ADDENDUM #2

**PIONEER PKWY &  
 N UNIVERSITY ST  
 RECONSTRUCTION**

PIONEER PKWY - PAVEMENT JOINT PLAN (1 OF 2)

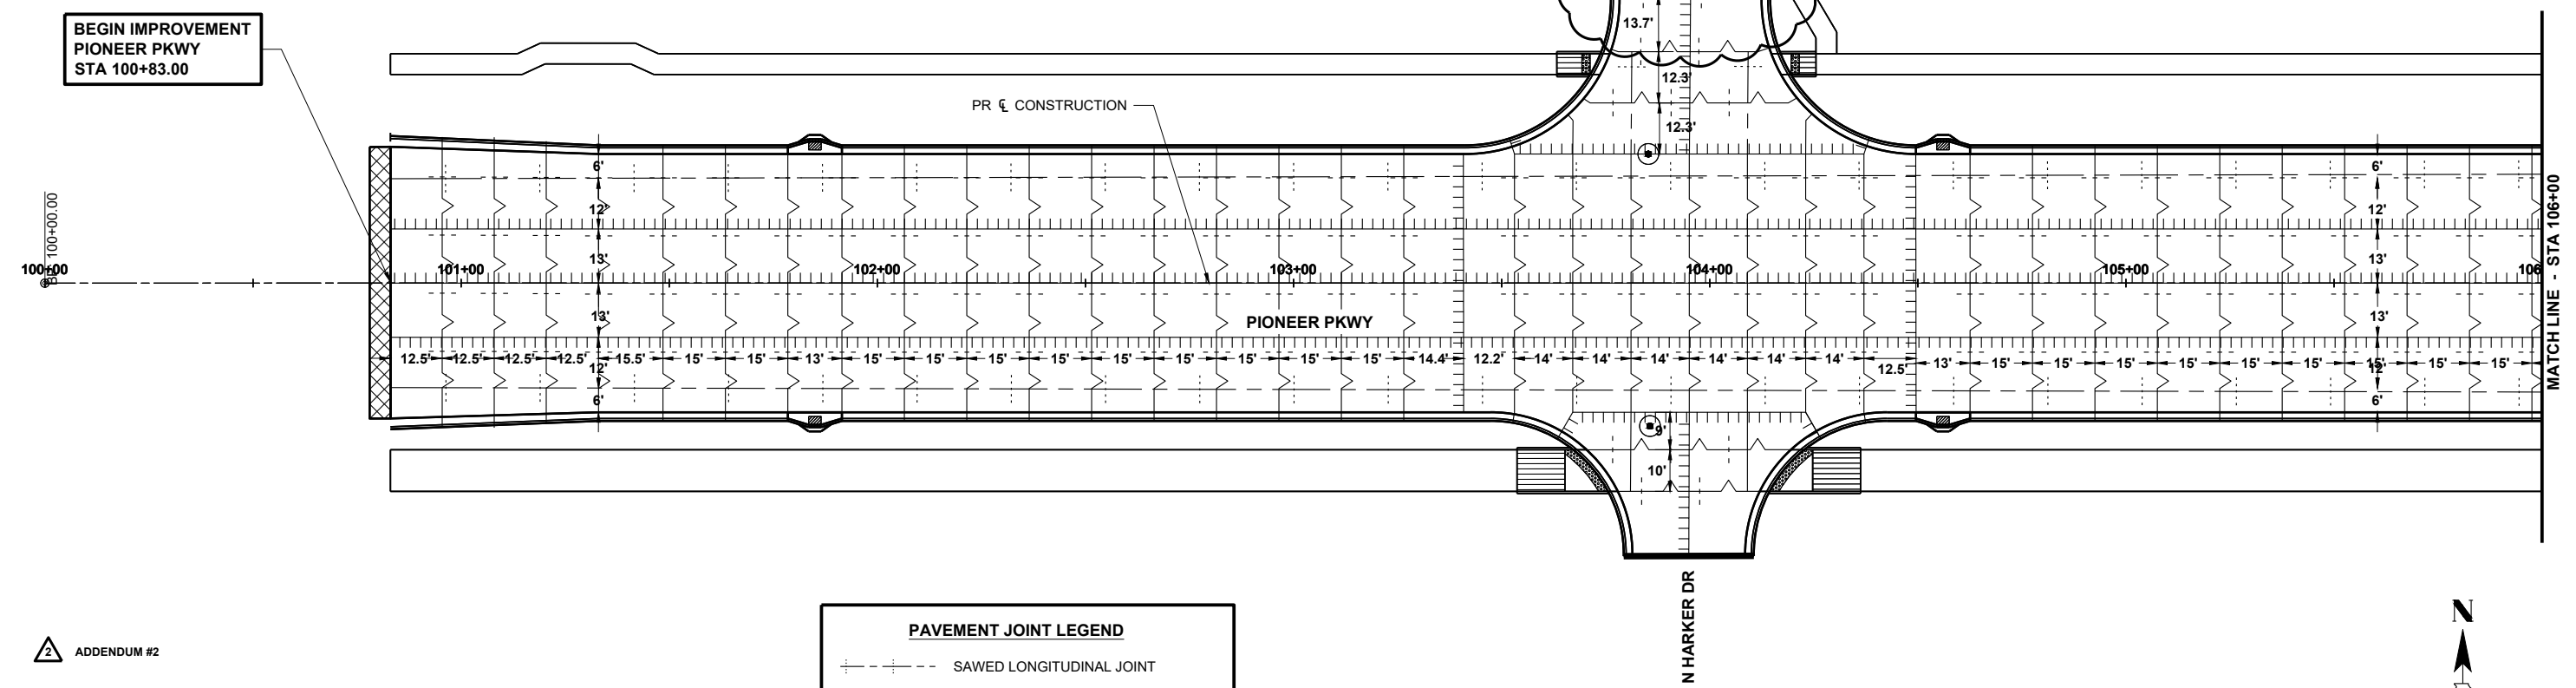
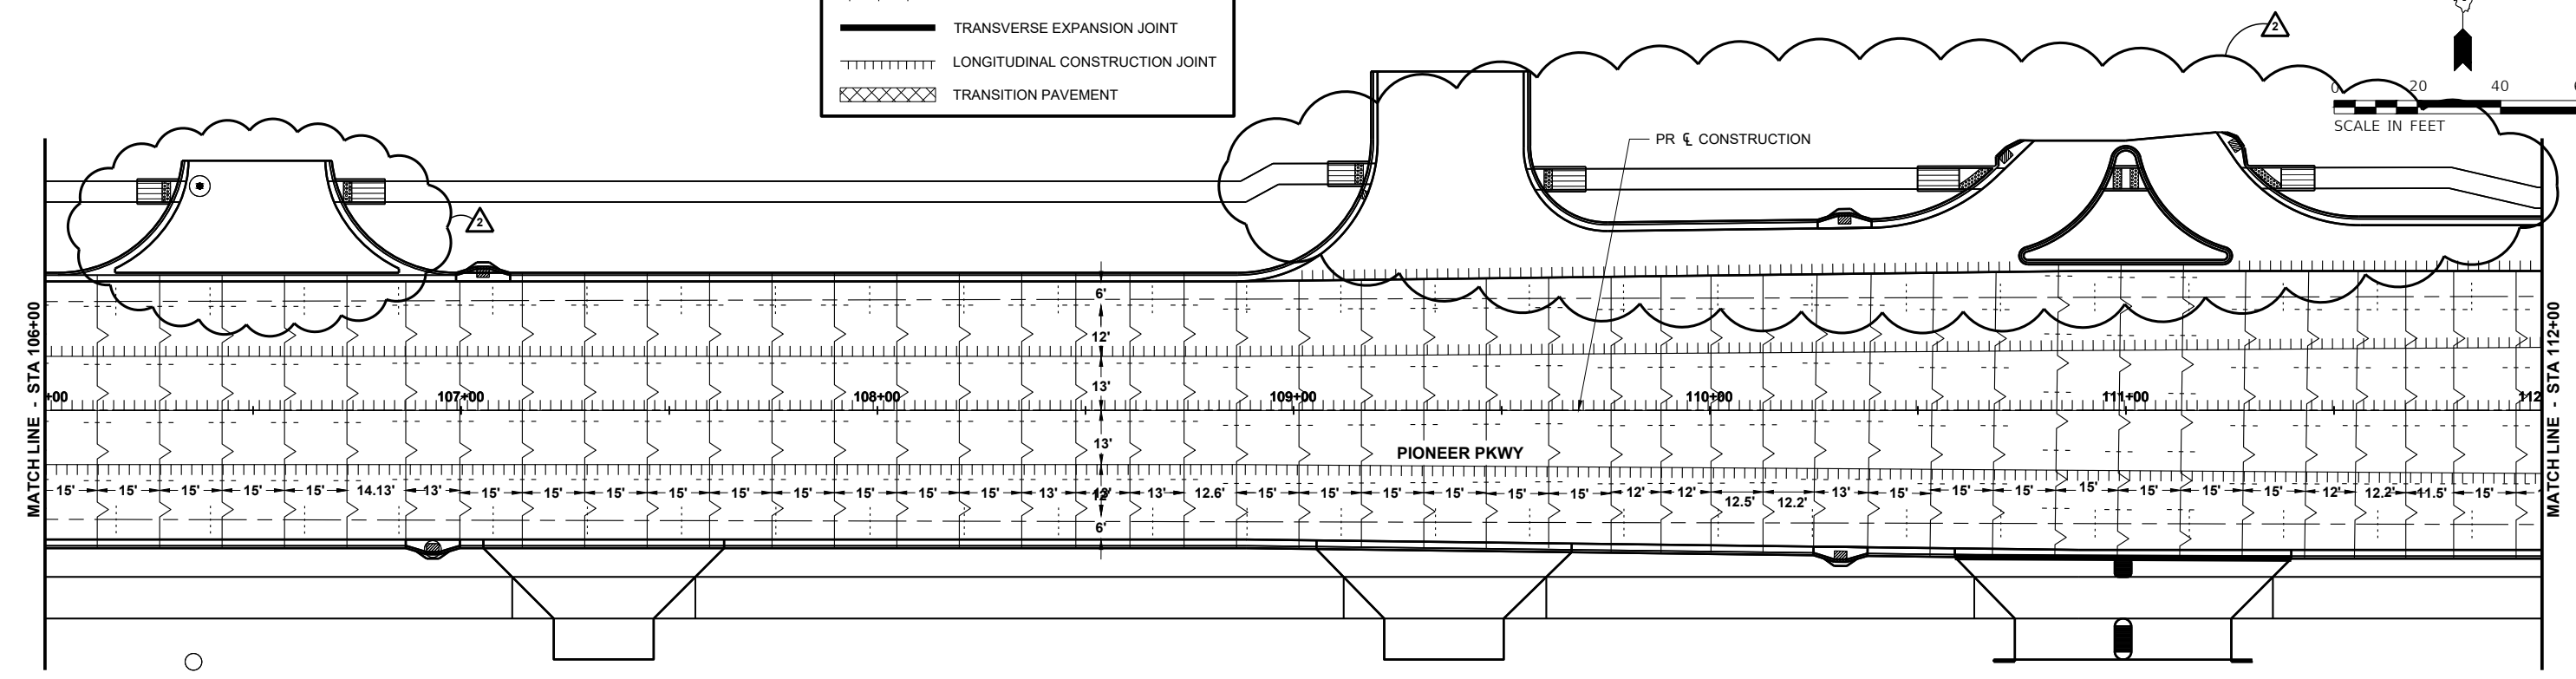
ADDENDUM #2
